Technical Service Bulletin

40 Rattling or knocking noise from front end when driving over bumps

40 14 39 2035854/2 February 13, 2014. Supersedes Technical Service Bulletin Group 40 number 13-37 dated December 3, 2013 for reasons listed below.

Figure 1. Lower guide link (1).

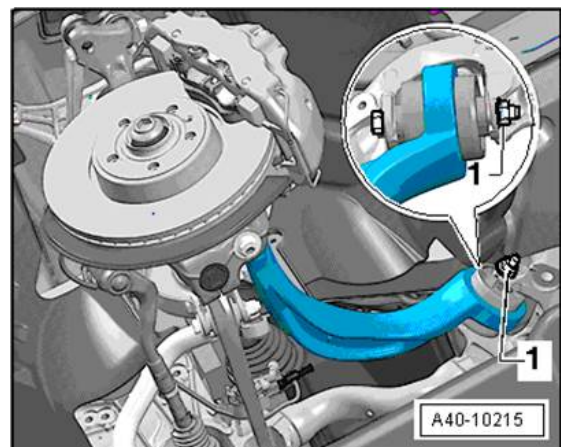
- **If the vehicle was produced with M14 ball joints:**
Replace both left and right lower guide links (Figure 1) according to the instructions in *Elsa >> Repair Manual >> Chassis >> Suspension, Wheel, Steering >> Front Suspension >> Removal and Installation >> Guide Link*.
